Subject: STC West River Resiliency Project

RCP&E STC Grant – West River Increasing Rail Resilience Project

SUMMARY OF RESULTS FROM H/H STUDIES ON RCPE STRUCTURES

(Proposed Changes from Grant Application Indicated in Red)

Proposed Structure & Riprap Protection

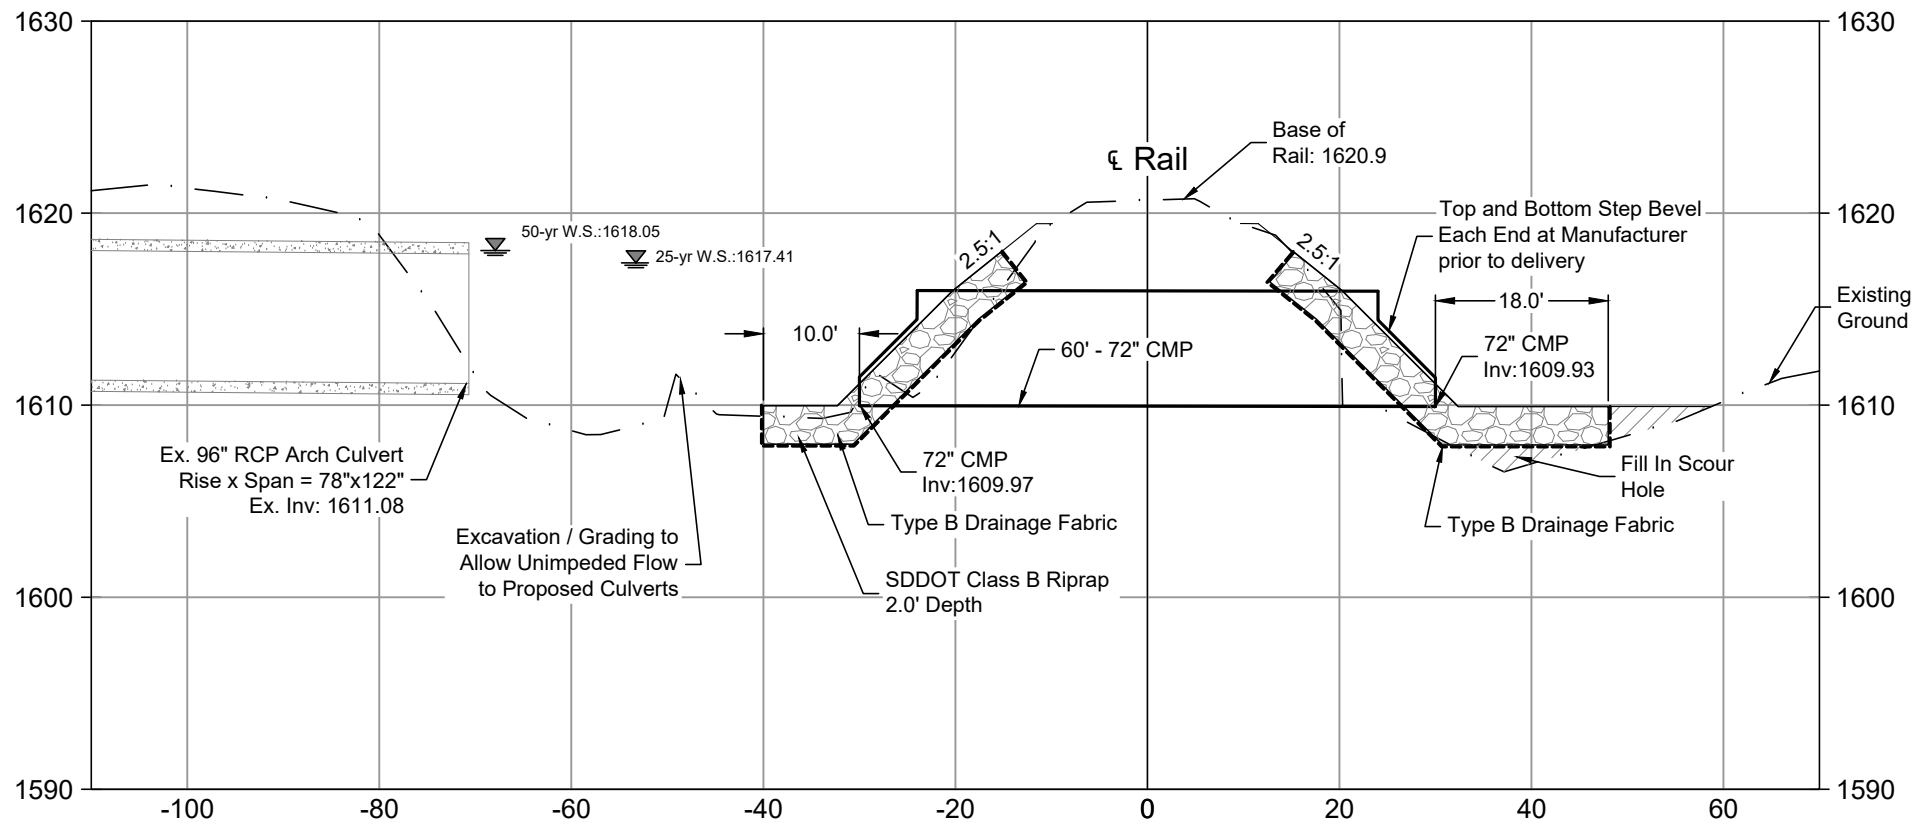
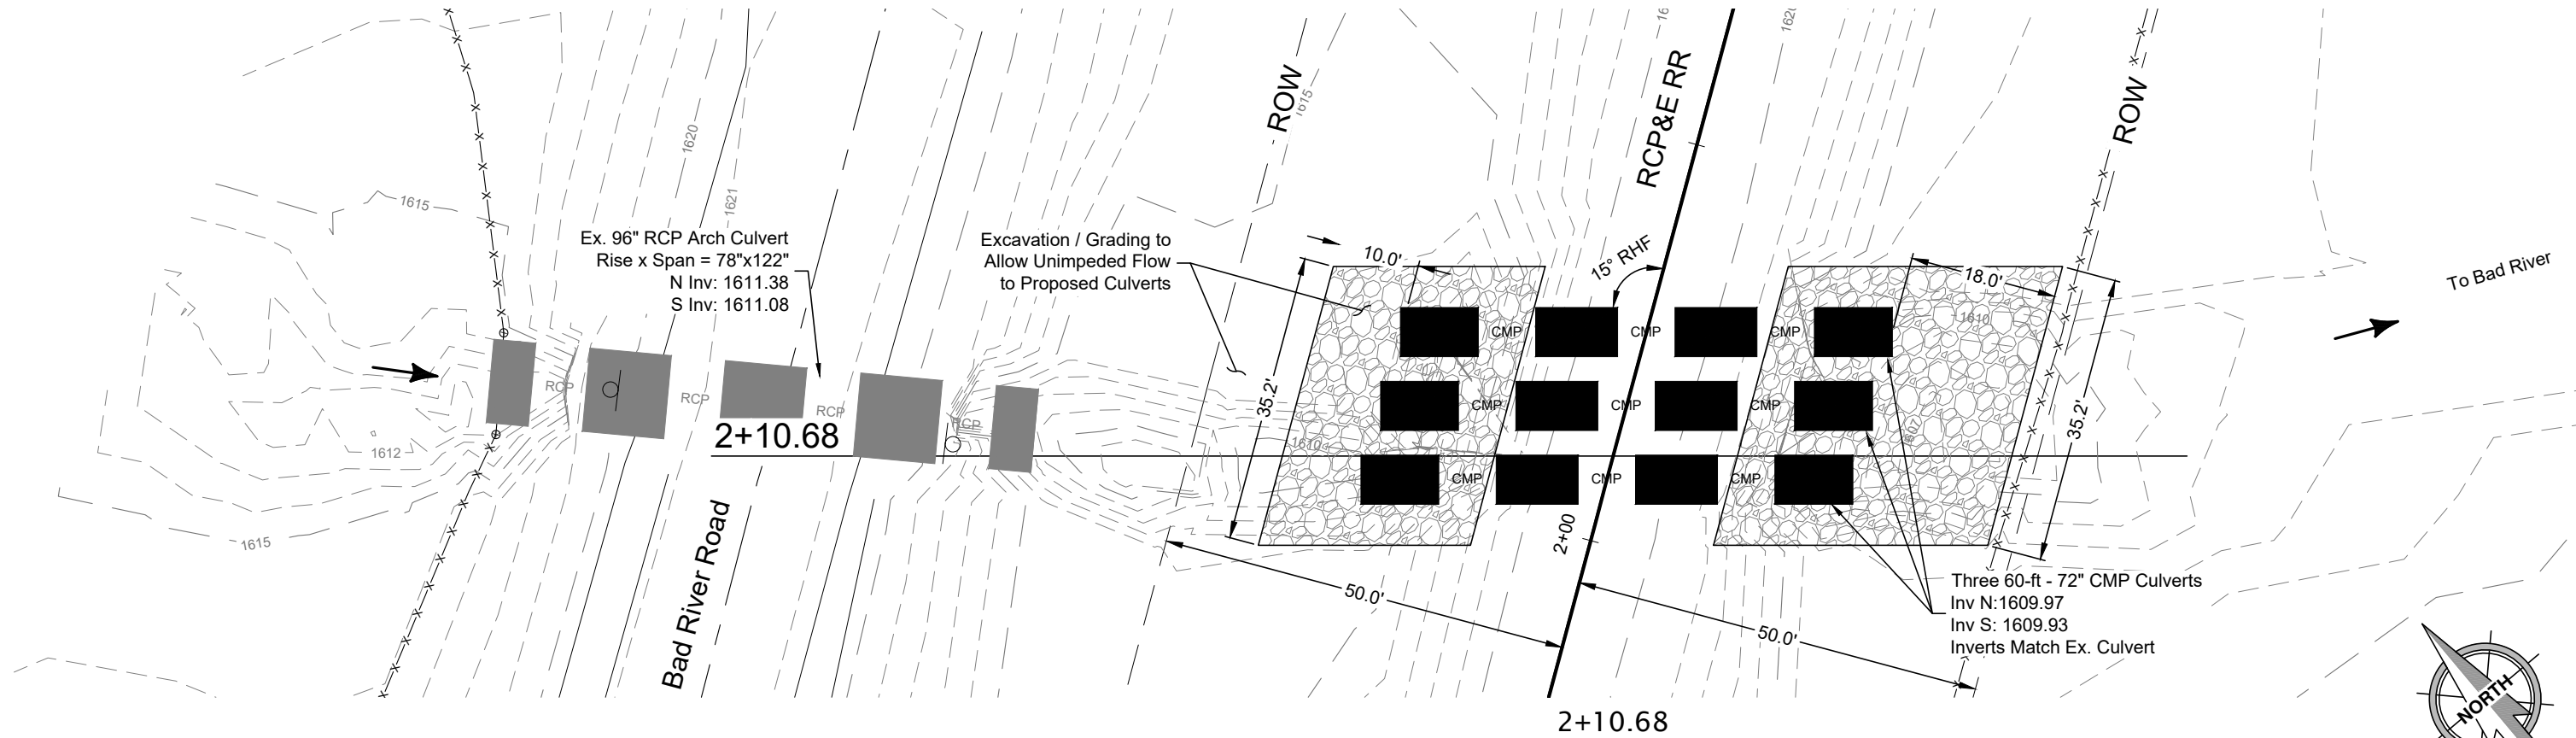
No.	Milepost	Existing Structure	Grant - Replacement Structure	CDI - Replacement Structure	Notes
1	506.80	Two - 60" CMP Culverts	Two - 72" CMP x 50-ft	Three - 72" CMP x 60-ft	Three culverts needed instead of two to meet hydraulic requirements, 60-ft needed to meet minimum slopes
2	517.93	36" CMP Culvert	60" CMP x 60-ft	60" CMP x 70-ft	This structure replacement is being removed from the Grant Application due to the following: Riprap extends downstream outside of ROW; 70-ft needed to meet minimum slopes / match existing; Downstream riprap important due to ex. headcut
3	530.25	96" CMP Culvert	Three - 72" CMP x 80-ft	Three - 72" CMP x 90-ft	This structure replacement is being removed from the Grant Application due to the following: Riprap extends upstream and downstream outside of ROW; 90-ft needed to meet minimum slopes
4	553.10	25-span Bridge	Infill 22 of 25 bridge spans	Strengthen Bridge to 286k	This work is being revised from the Grant Application due to the following: Infilling of bridge spans increases 100-yr by 2.1-ft on south side of bridge; SDDOT & FEMA allow 1-ft max rise; Proposed 50-yr water surface on south side of mainline is at ballast elevation from MP 552.95 to 552.85 (500-ft); A new overtopping occurs between 100-yr and 500-yr event that does not occur under existing conditions & overtopping at ex. overtopping location still occurs between 25-yr & 50-event; high velocity & high potential for bridge scour with narrow opening; South side refuge islands for cattle eliminated or greatly reduced during the 50-yr event

Proposed Structure & Riprap Protection

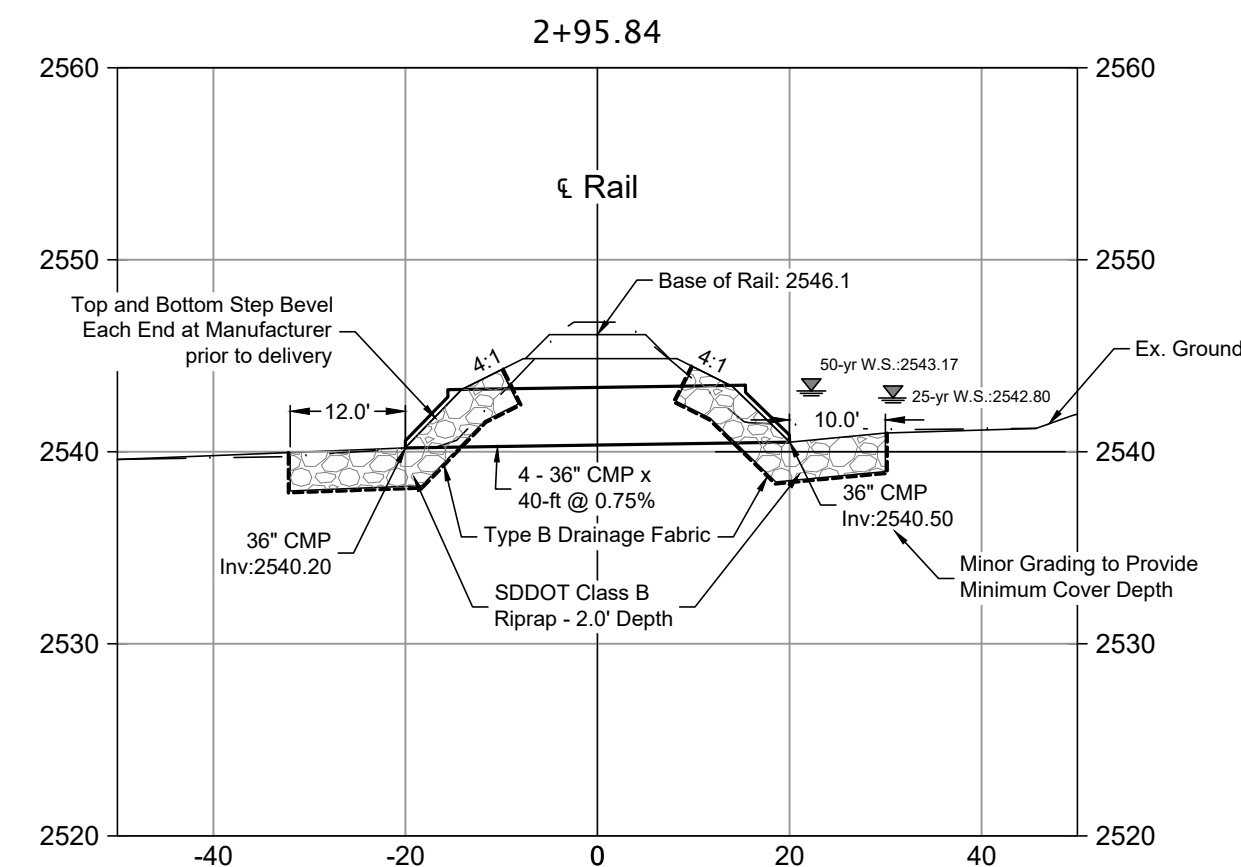
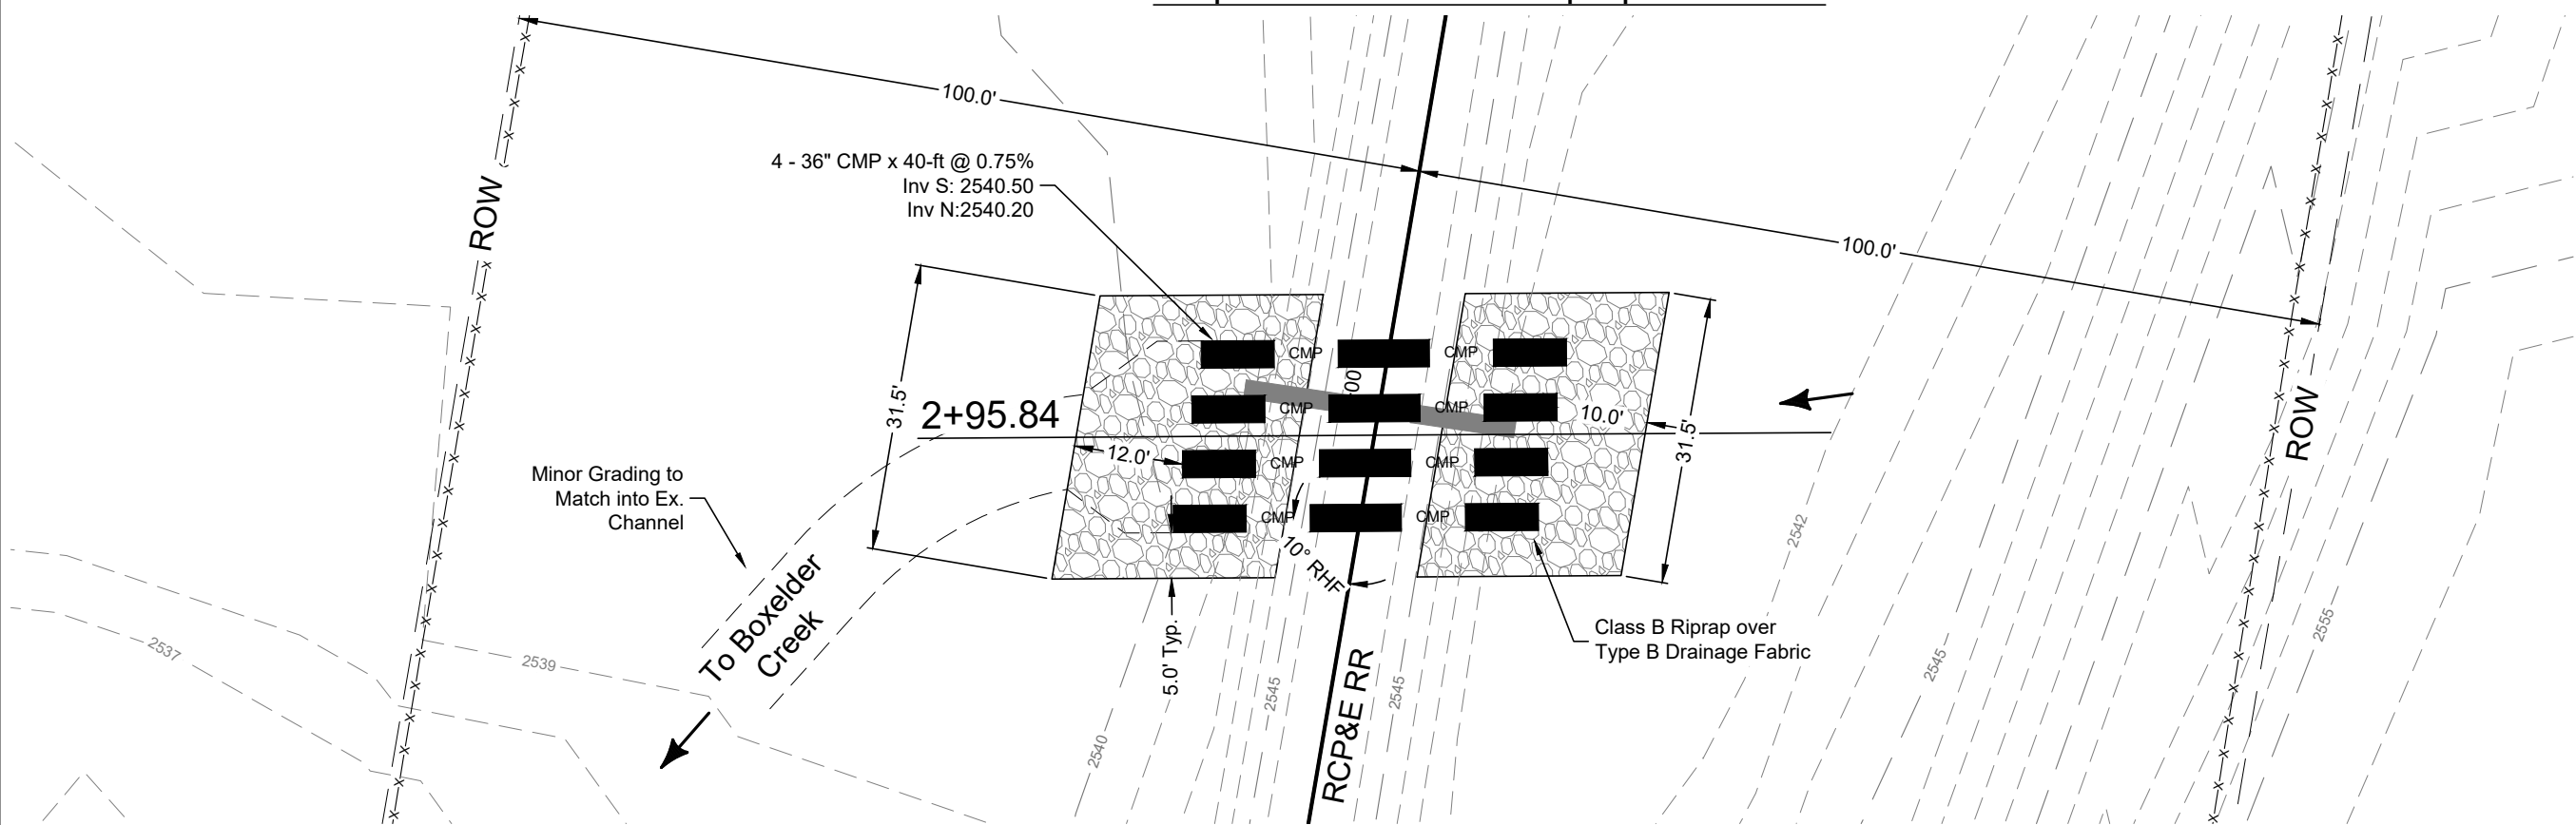
5	616.70	24" CMP Culvert	4 - 36" CMP x 40-ft	4 -36" CMP x 40-ft	Proposed culverts provide relief to Bridge at 616.90 and reduce ditch flows on the south side of the RCPE ML.
6	617.15	None	Two - 48" CMP x 40-ft	Two - 48" CMP x 40-ft located approx. 80-ft southeast of southeast bridge abutment (MP 617.26)	Proposed location directs flows across private property; Culverts do not reduce potential for overtopping. The addition of culverts simply reduce flows through Bridge at 617.30. Proposed location will be approximately 80-ft southeast of southeast abutment to direct flows back into stream within existing ROW.
7	620.35	Grant Indicates No - Survey Found Ex. 36" RCP Culvert	Three - 72" CMP x 80-ft	Single 60" CMP x 50-ft	Berm on east side of Bridge at 620.60 keeps flows from entering the ditch to just prior to the 50-yr event; proposed structure is hydraulically equivalent to the existing 36" RCP & reestablishes the flow capacity; The proposed 60" CMP structure will meet the HDCs of the railroad.

Proposed Structure & Riprap Protection

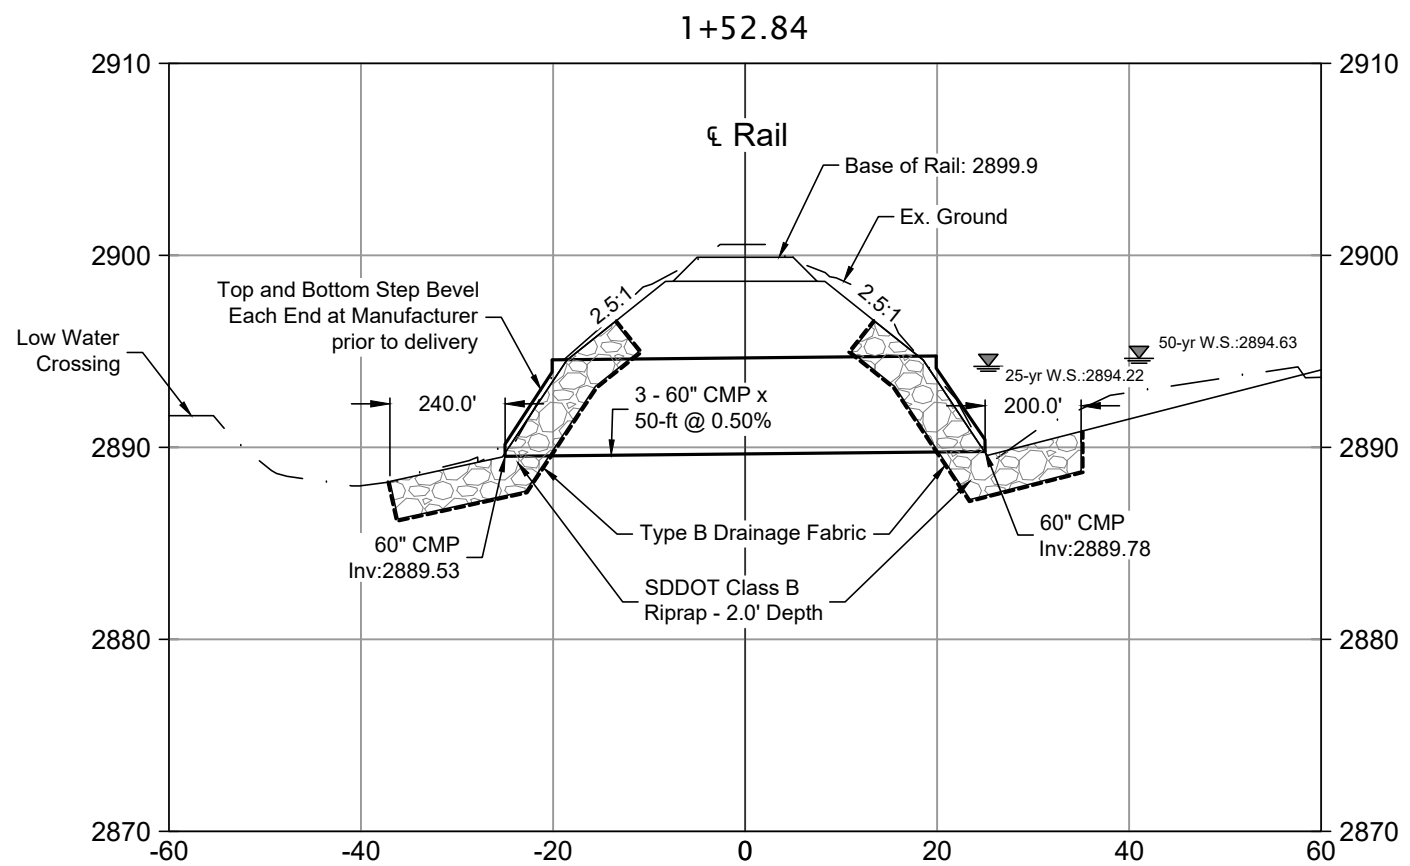
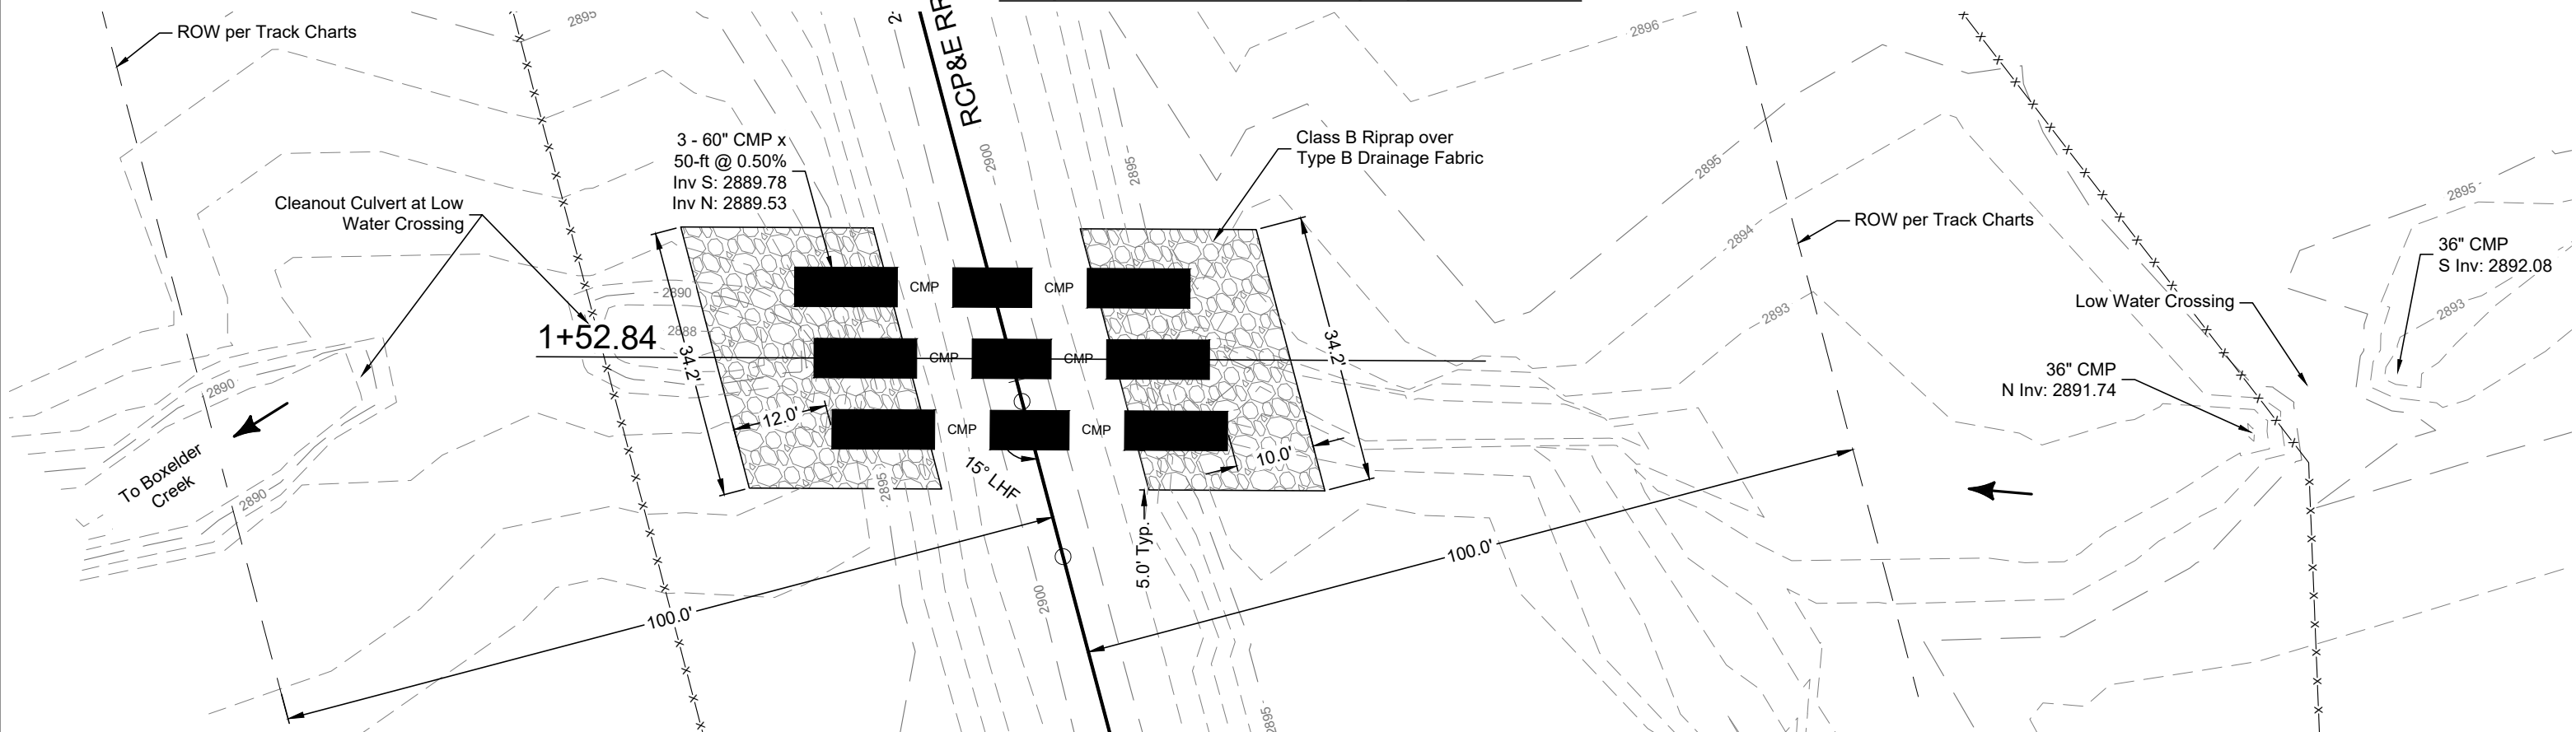
8	632.60	48" CMP Culvert	Three -60" CMP x 50-ft	Three - 60" CMP x 50-ft	Existing conditions results in overtopping between the 10-yr and 25-yr event; development occurring upstream; The proposed culverts exceed RCPE HDC's and provide some additional capacity for development and for routing over downstream low water crossing.
